DEVELOPMENT DETERMINATION PANEL MEETING

THURSDAY 1 FEBRUARY 2018

| 3.1 | N0356/17 - 10 Mountview Place, Bilgola Plateau - Construction of a new dwelling including the retention of a substantial portion of the existing dwelling | 2 |

**N0356/17 - 10 MOUNTVIEW PLACE, BILGOLA PLATEAU -
CONSTRUCTION OF A NEW DWELLING INCLUDING THE
RETENTION OF A SUBSTANTIAL PORTION OF THE EXISTING
DWELLING**

Figure 1 - North-west elevation

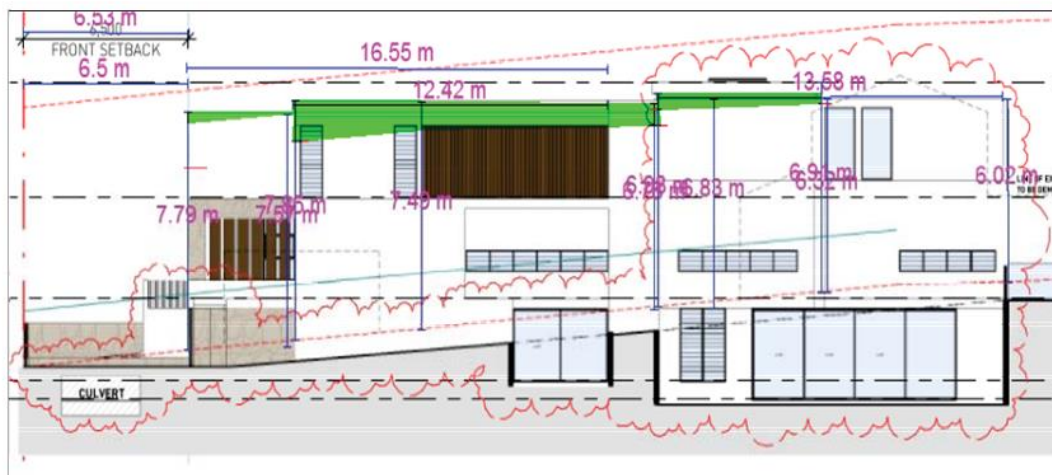
The proposed development results in non-compliances with the side boundary envelope control on the south-east and north-west elevations.
